ADDENDUM NO. 1

ISSUE DATE: April 4, 2018

CRC College Center Expansion

LRCCD BID NO. 17021

SHEET NO:
A5.01

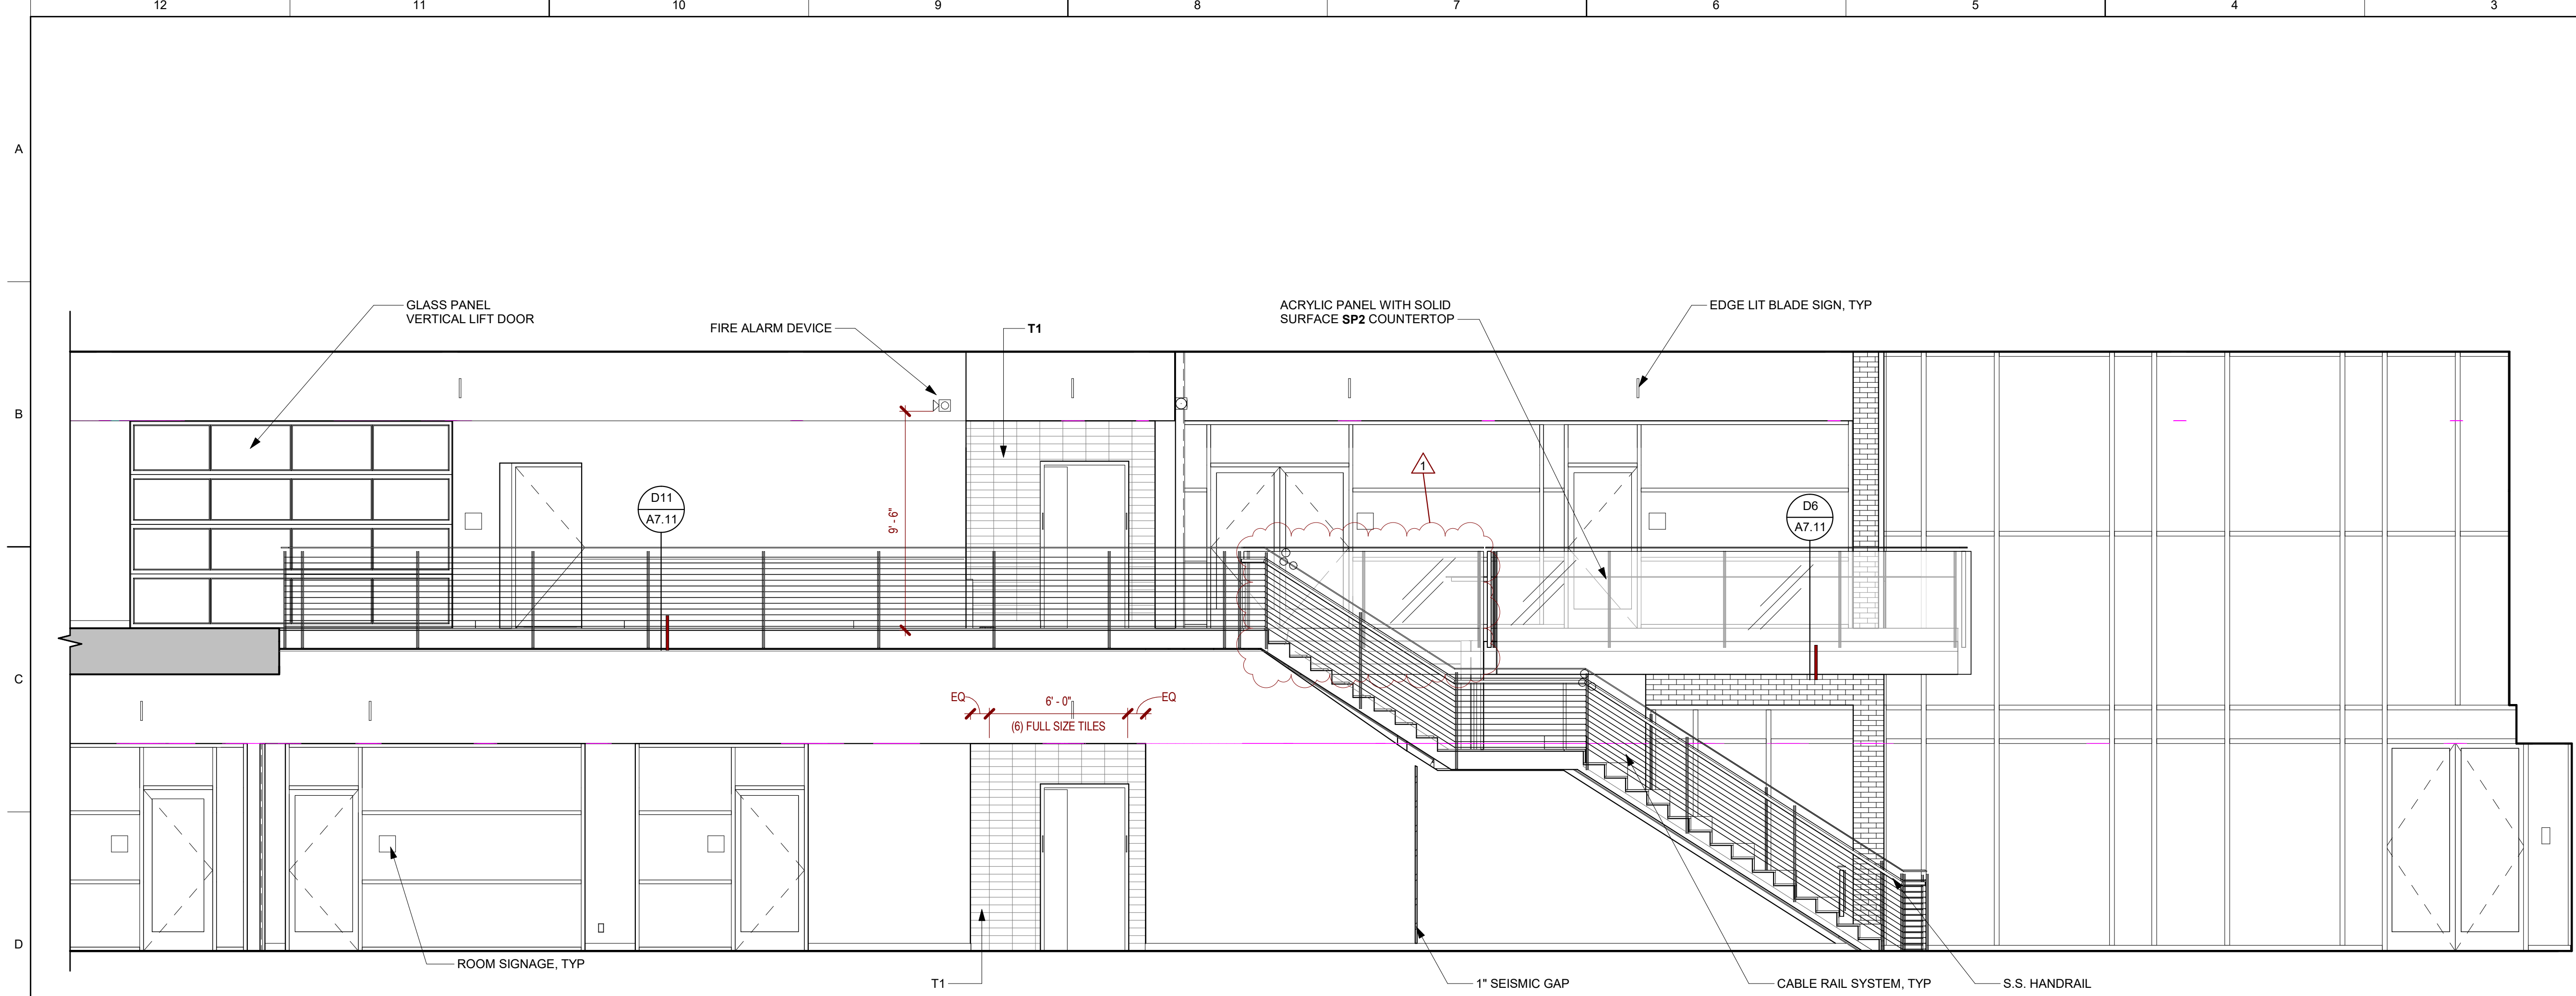
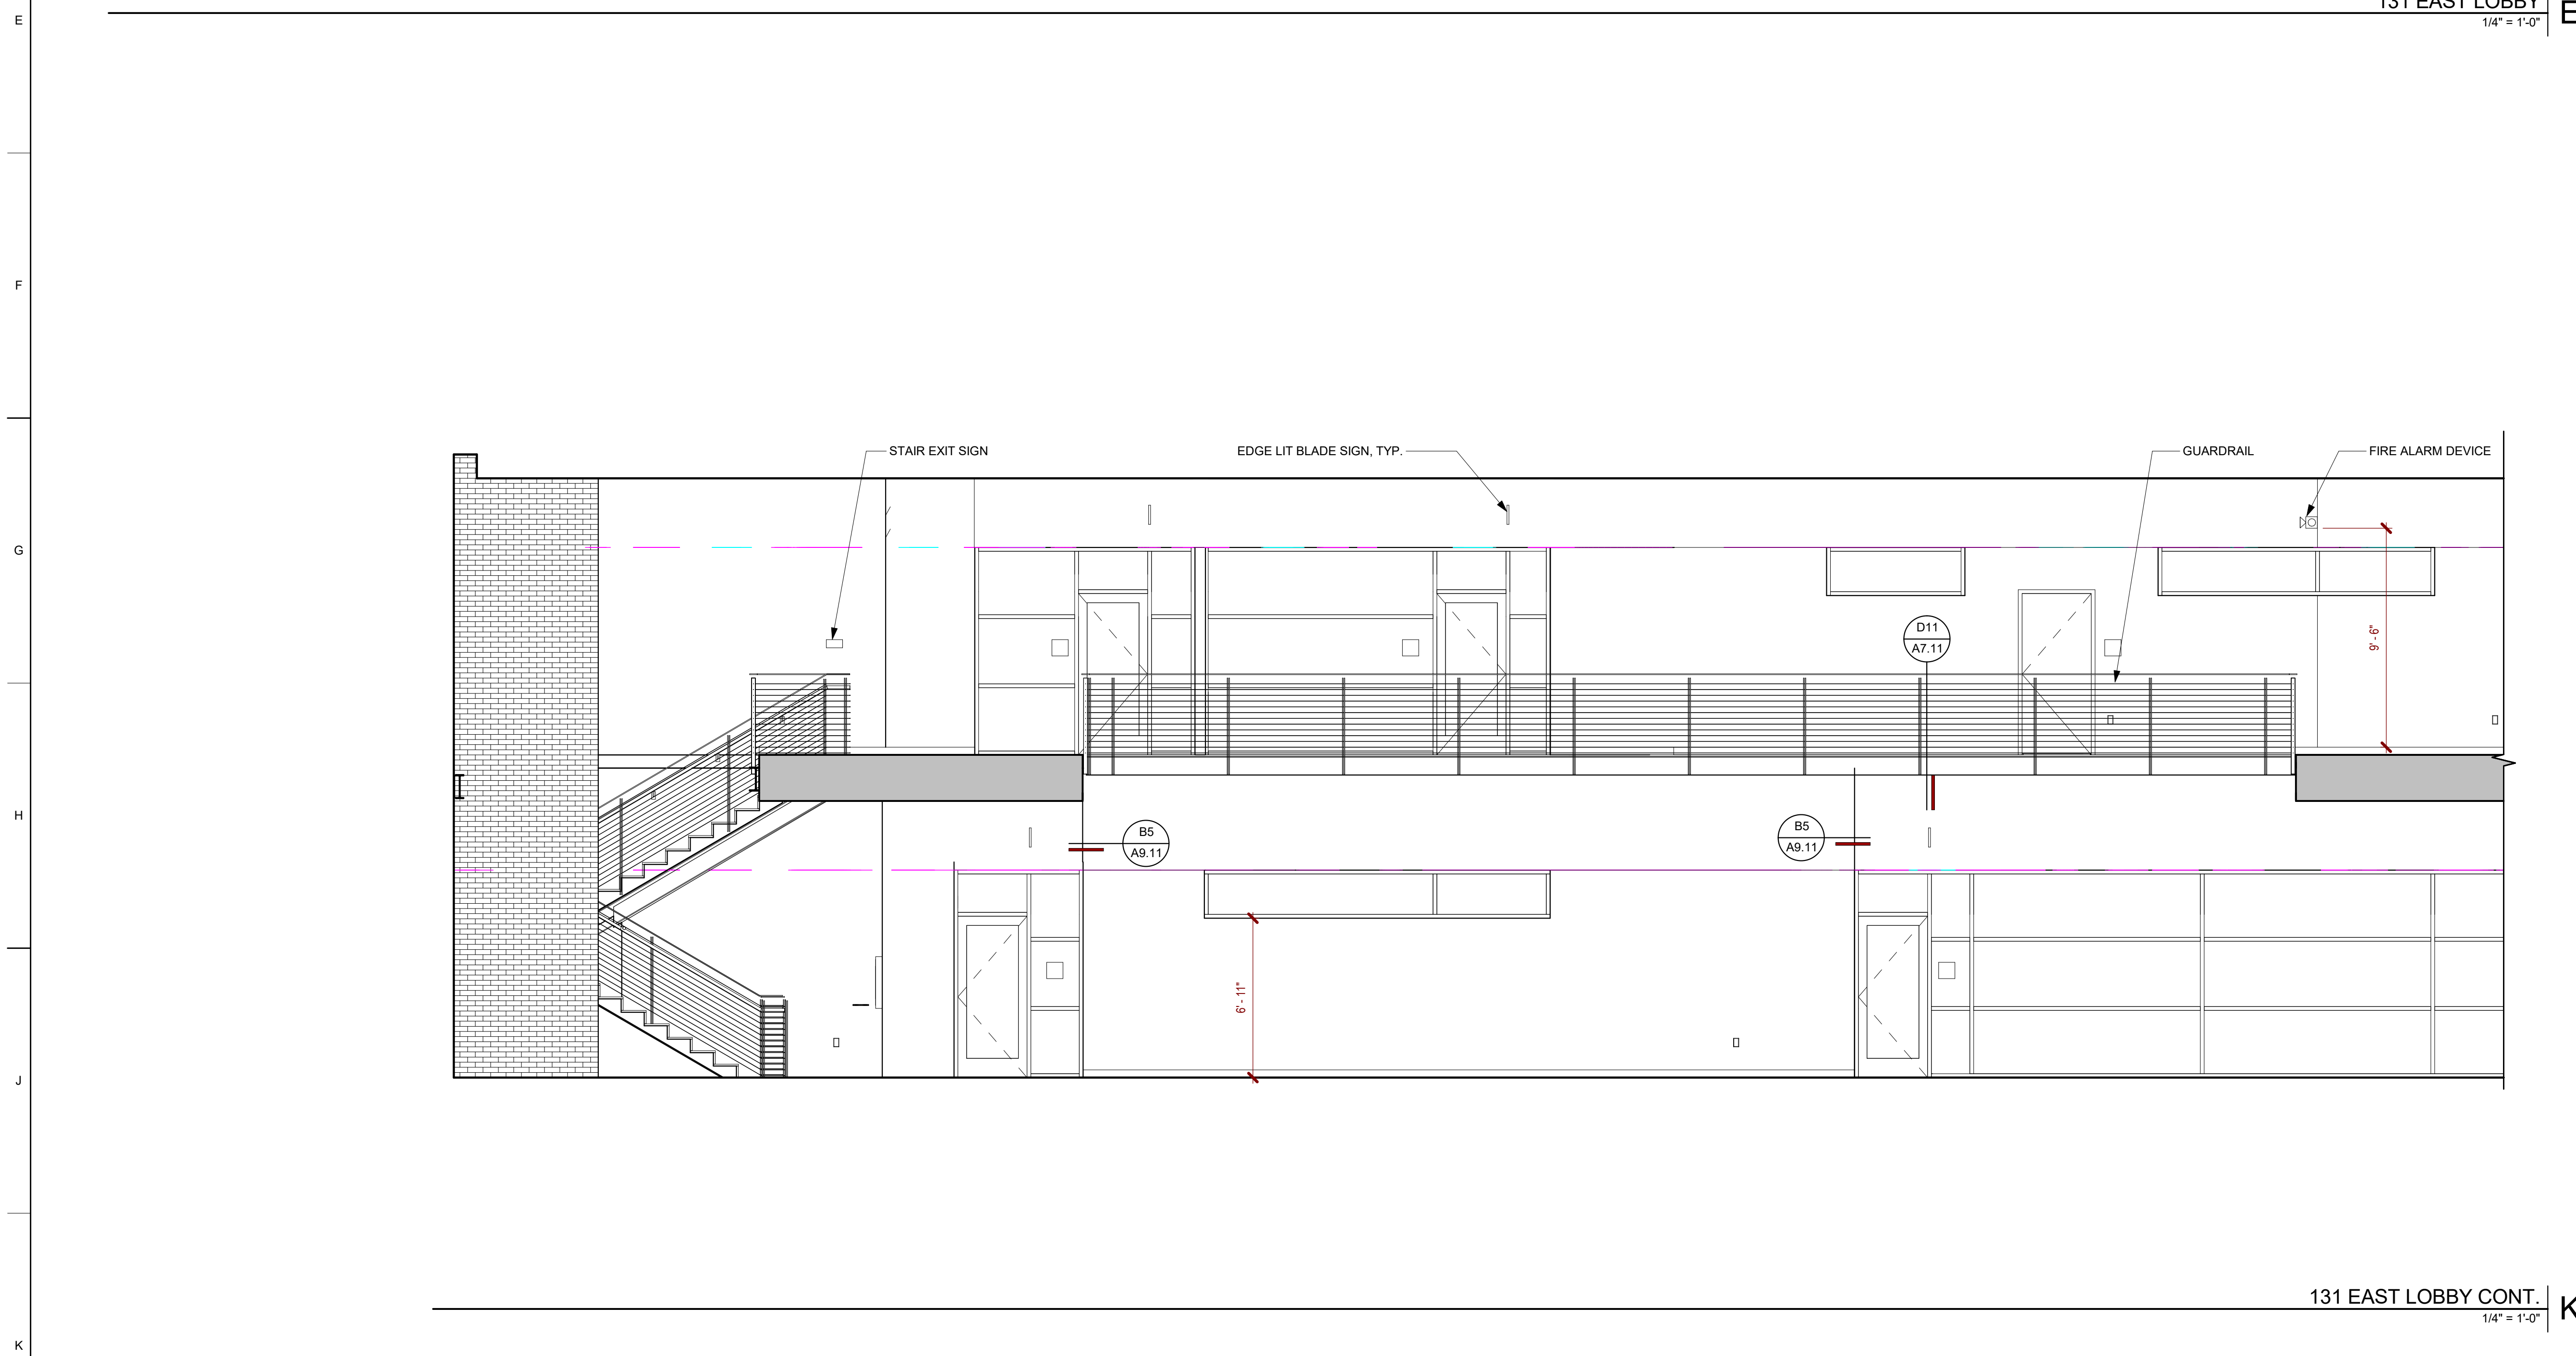
- A5.01 – Modified interior elevation with updated information
- A5.02 – Modified interior elevation with updated information
- A5.03 – Modified interior elevation with updated information
